City of Portland, Oregon
Bureau of Development Services
Land Use Services

NOTICE OF A TYPE II DECISION ON A PROPOSAL IN YOUR NEIGHBORHOOD

CASE FILE NUMBER: LU 13-233013 AD

Proposal: The applicant, McDonald's USA, intends to rebuild its current drive-through restaurant facility on the site. The project will include a new building that will be located within 10 feet of the south (SE Powell Blvd) property line. There will be new drive-through stacking lanes as well as a new parking and landscaping configuration. The project will include pedestrian connections from SE Powell to the entrances.

SITE PLAN

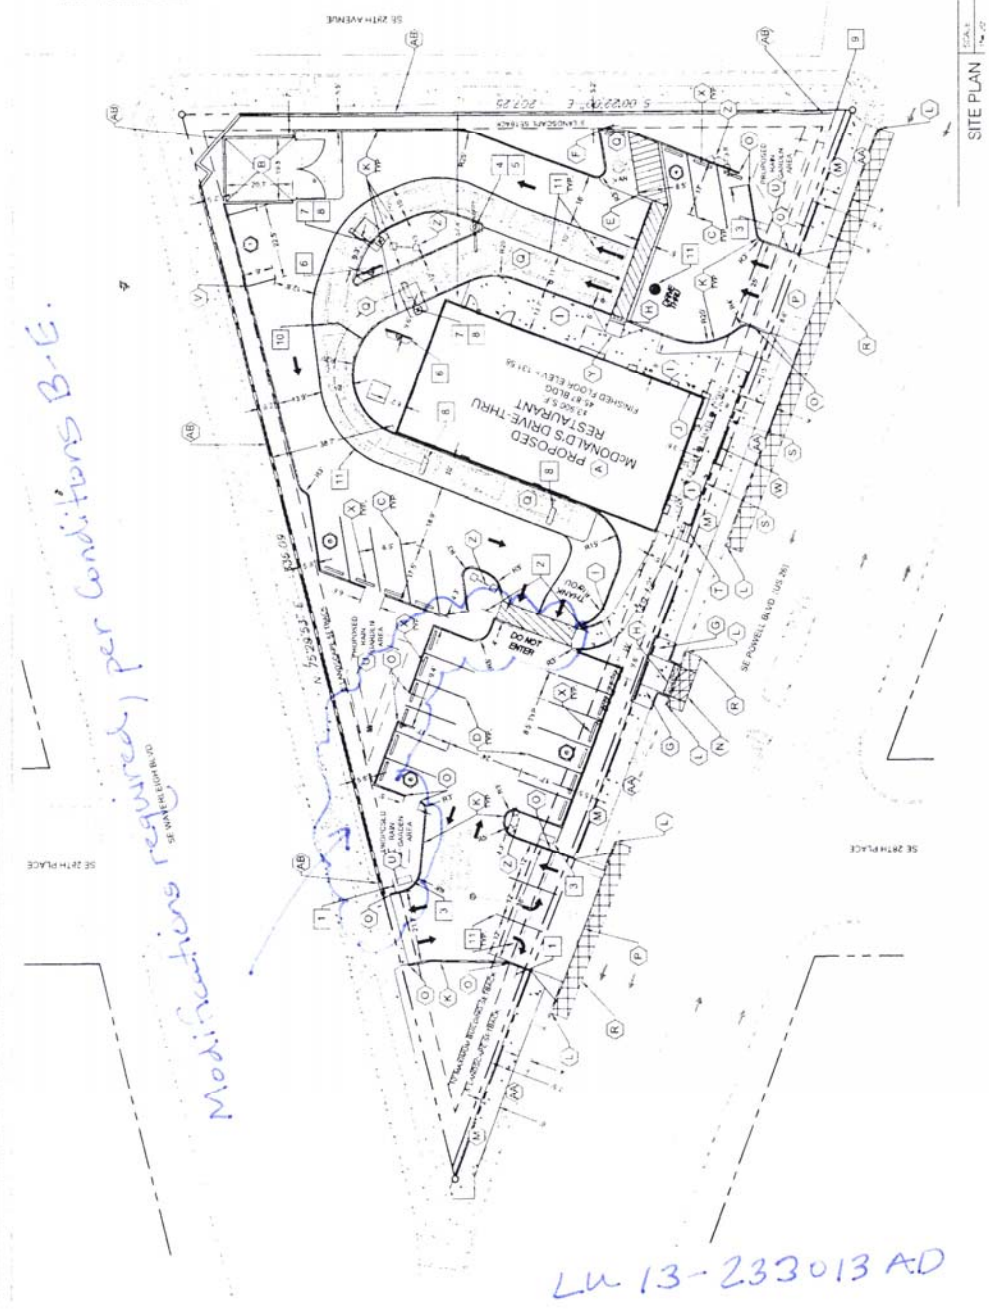
In contrast, staff finds that the pedestrian connection requirement should not be waived for the required connection for pedestrians who are traveling from the west and north or for those who park at the site and walk to the building entrance. The design of the required stormwater infiltration facilities, parking area and required perimeter parking lot landscaping can be altered to provide an adequate pedestrian connection. An Adjustment to reduce the required width of the pedestrian connection from 6 to 4 feet will provide a reasonable modification that still provides a safe, useable system. The on-site walkway can begin adjacent to SE Waverleigh curb cut approach, follow the north property line while still maintain the proposed landscape areas identified as the rain garden/stormwater infiltration area. Then, the walkway can be located on northern edge of the parking spaces to connect to the pedestrian walkway that leads to SE Powell main entrance. The attached site plan (Exhibit C.1) identifies the location of the required 4 foot wide walkway. Except in one location, there is adequate area available to accommodate both a 4-foot wide walkway and the required 5-foot deep perimeter parking lot landscape area. The proposed parking space that is located in the northwest edge of the parking area may need to be removed. SE Powell has frequent bus service and therefore there is no minimum required number of on-site parking spaces. A reduction of one space will not adversely impact the viability of the project. Furthermore, so that vehicles may not significantly extend into the pedestrian pathway, a condition will require the installation of wheel stops that must be located 1 foot back from

the curbing that edges the parking. This will limit the amount, to approximately 1 foot, of vehicle overhang into the 5-foot wide pedestrian corridor. The Zoning Code requires 90-degree parking spaces to be 16 feet deep. The applicant has designed the parking lot with 17 feet deep spaces and wide aisles. To meet the perimeter parking lot landscaping requirement, a condition will require a continuous row of evergreen shrubs be planted, either on the south or north side of the walkway.

Curbing, wheel stops and landscaping will serve to separate the pedestrian connection from vehicle areas. Where the pathway crosses a vehicle path, it must be a raised or different surface, such as concrete, than that which is used for the parking lot. A condition will require the pedestrian walkway to be a different surface than what is used for the parking lot. Lastly, for safety during night time hours, a condition will require the applicant to provide adequate lighting for the entire length of the connection--from both SE Waverleigh and Powell to the main building entrance. With conditions, this approval criterion is met.

Approval of an Adjustment to waive the on-site pedestrian connection requirement from SE 29th Avenue to the SE Powell Blvd restaurant entrance and to reduce the required width of the on-site pedestrian connection from 6 feet to 4 feet for the connection between SE Waverleigh and the SE Powell entrance [Section 33.130.240], per the approved site plan, Exhibit C.1, signed and dated February 3, 2014, subject to the following conditions:

- B. The on-site pedestrian connection between SE Waverleigh and the main entrance must be comprised of a non-asphalt hard surface such as concrete or concrete pavers.
- C. Where the pedestrian connection abuts the parking area, it must be separated by a curb and wheel stops. The wheel stops must be placed at least one-foot behind the curb.
- D. Where the pedestrian connection is located between the parking area and the north property line, the required 5-foot deep landscape area must include living groundcover and a continuous row of evergreen shrubs that will mature to at least a height of 3 feet, consistent with the L2 landscaping standard.
- E. Lighting must be installed at or near the on-site pedestrian system so that the system may be used during night-time hours.
